Preliminary Assessment Report Prince Wind Park

Applicant: Superior Wind Energy Inc.

CAA ID 2002-076

Final Report

Figure 1. Proposed Configuration of the 100MW Prince Wind Park Project

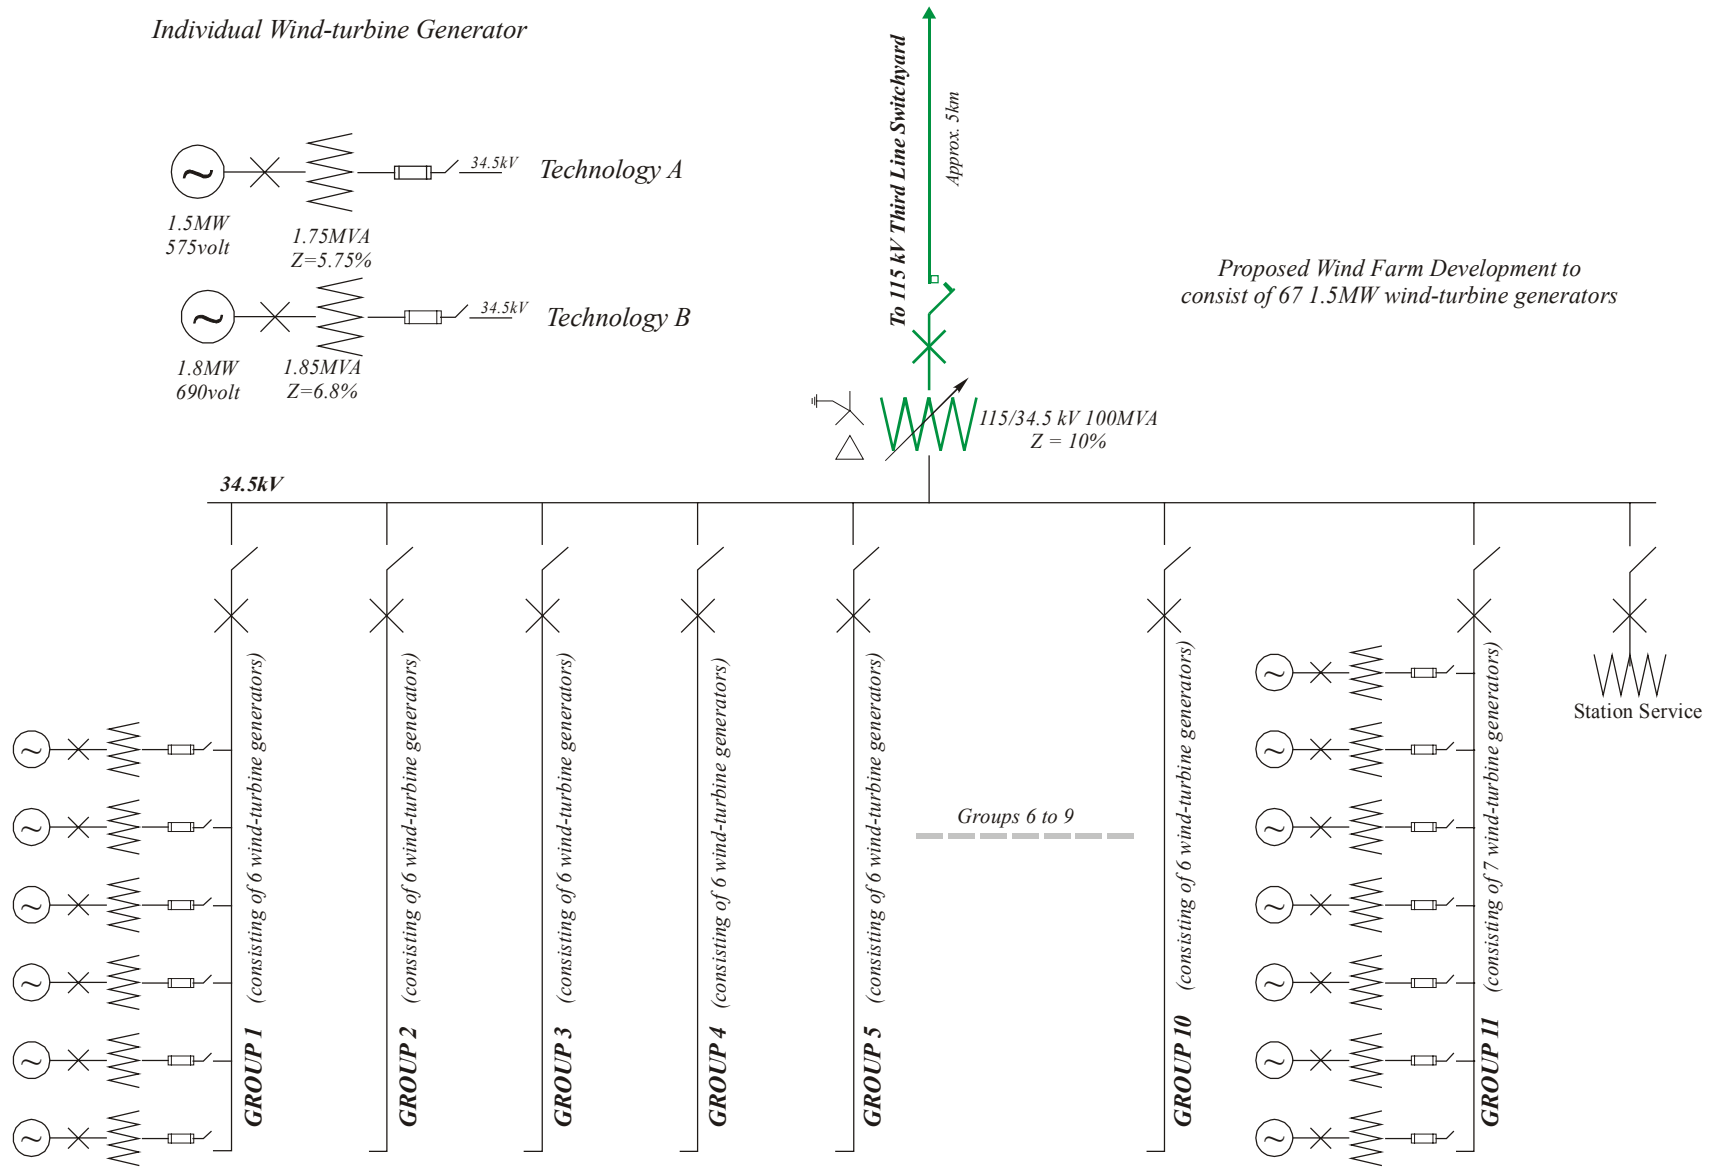
34.5 kV breaker to a common 34.5 kV bus. The connection to the 115 kV line is provided via one 115/34.5 kV transformer bank, a 115 kV breaker and a disconnect switch. Figure 1 shows the proposed arrangement for the 100 MW wind park.

The Transmission System Code specifies that the standard transformer winding connection is LV delta and HV wye and that any other configuration has to be approved by the transmitter. The main 115/44 kV step up transformer winding configuration will be delta on the LV side and wye on the HV side; this meets the code requirements.

Superior Wind Energy Inc. is advised to seek approval from GLPL with respect to winding configuration and grounding requirements if the proposed connection arrangement is different than the standard.

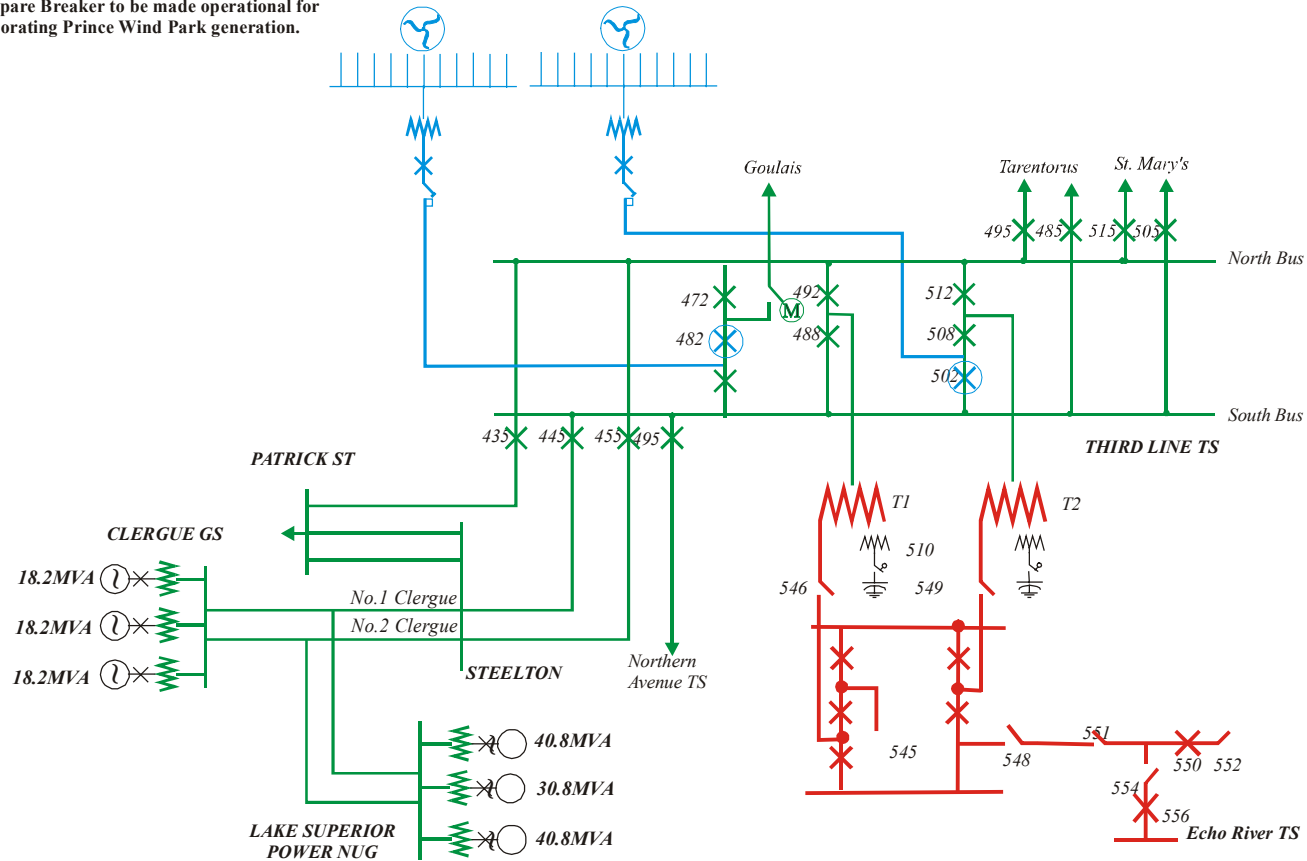
The proposed connection point of the wind generation to the Great Lakes Power system at Third Line TS is shown in Figure 2. This configuration assumed that the preferred option for transmission reinforcement that was proposed by GLPL and approved by the IMO would be completed by the time the wind generation development is to be commissioned. The wind farm is to be incorporated via a 5 km line tap which is to connect to the Third Line 115 kV switchyard. After the implementation of the GLPL transmission reinforcement the 115 kV switchyard at Third Line will have three spare breaker positions where the new generation could be connected.

It is recommended that the wind generation be connected on the same diameter as the Sault No.3 115 kV circuit. A spare 115 kV breaker (i.e.482) could be used to complete this diameter, which would be equipped with only two breakers upon completion of the transmission reinforcement.

Figure 3. Required Configuration for the Incorporation of 200MW Wind Turbine Generation

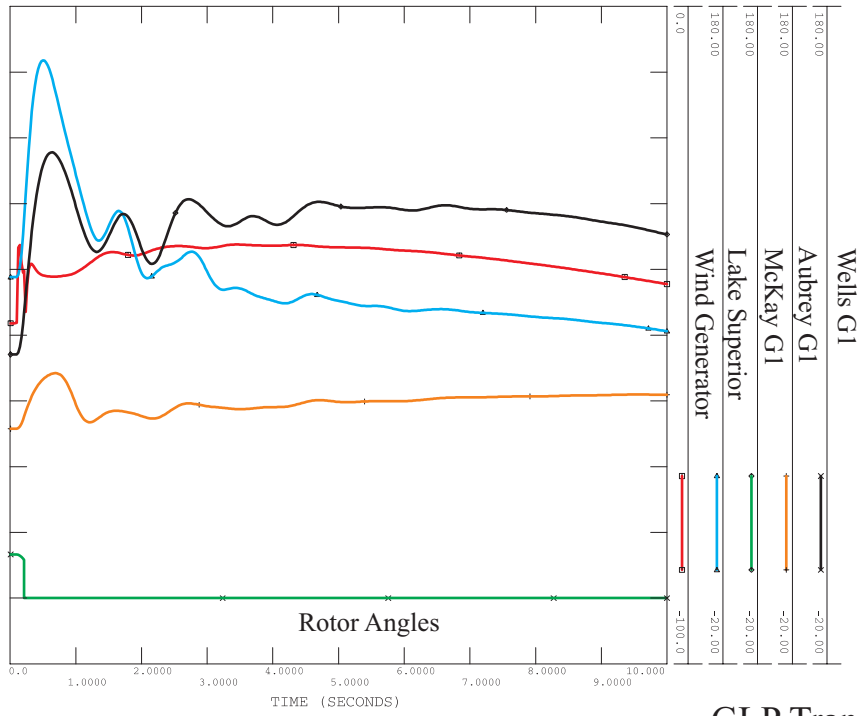
It is thus required that Superior Wind Energy Inc. incorporate each 100 MW wind turbine generation group via a dedicated 115 kV connection into Third Line TS, as shown in Figure 3. The connection of the second 100 MW wind turbine generation into Third Line 115 kV switchyard shall use one of the spare positions available on the diameters where T1 or T2 are connected.

- Incorporate each 100 MW wind turbine generation group via a dedicated 115 kV line connection into Third Line TS and provide all the necessary station equipment.
